SERVICE BULLETIN

SB-19-006

Reefer Side Skirt Attachment Improvement

UTM Reference: #362767

INSTALLATION INSTRUCTIONS:

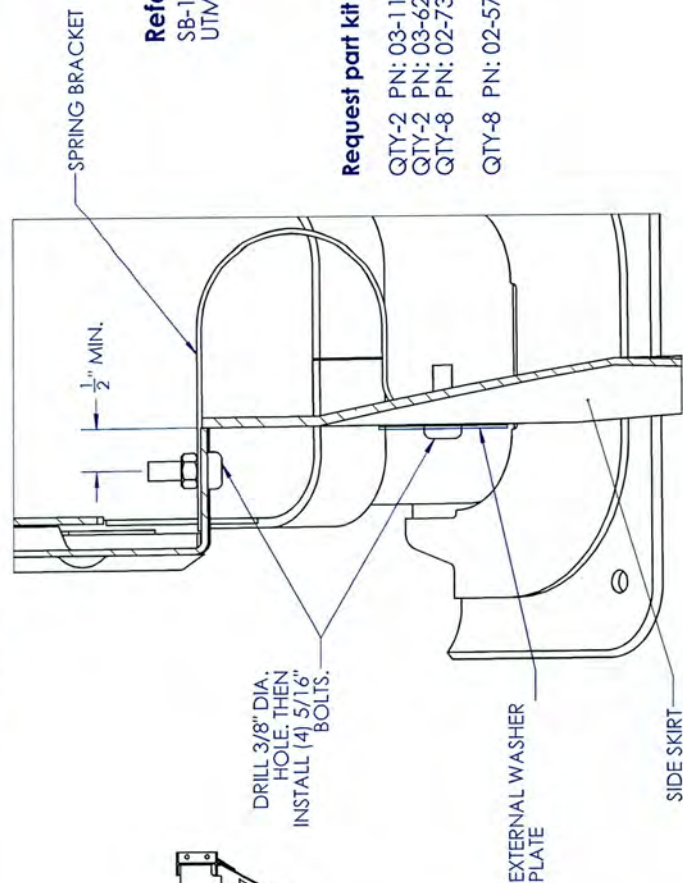
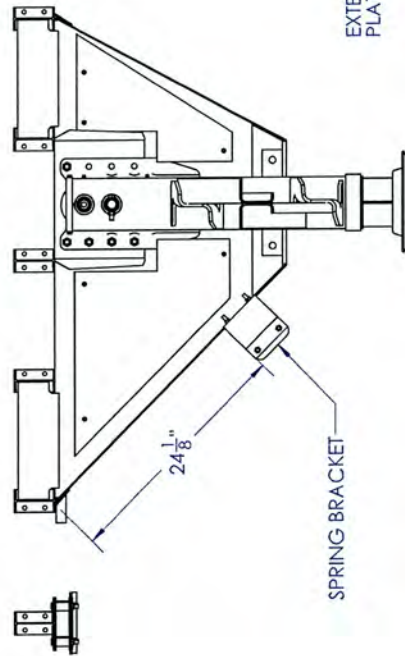
Forward Attachment Improvement
For Reefer trailers only, built between May 2011 and May 2012.
The new spring bracket accommodates diagonal struts located 24" or 48" aft of the wing plate. An additional diagonal strut is not required.

- ① ROADSIDE SHOWN, CURBSIDE OPPOSITE.
- ② LOCATE THE WING PLATE SLIP-FIT EXTRUSION, DRILL OUT THE EXISTING RIVETS, AND REMOVE EXTRUSION.
- ③ POSITION THE WING PLATE SPRING BRACKET TO THE SKIRT AND TO THE INSIDE FLANGE OF THE WING PLATE AS SHOWN.
- ④ LINE DRILL (2) 3/8" DIA. HOLES THROUGH THE SPRING BRACKET AND INTO THE WING PLATE FLANGE (MIN. EDGE DISTANCE OF 1/2"); THEN FASTEN WITH (2) 5/16" NUTS AND BOLTS. (12-15 FT-LBS). DO NOT DAMAGE SKIRT.
- ⑤ LINE DRILL (2) 3/8" DIA. HOLES THROUGH THE SPRING BRACKET AND INTO THE SKIRT; THEN FASTEN WITH (2) 5/16" NUTS AND BOLTS AND (1) WASHER PLATE ON THE EXTERNAL SIDE OF THE SKIRT. (12-15 FT-LBS). DO NOT DAMAGE SKIRT.
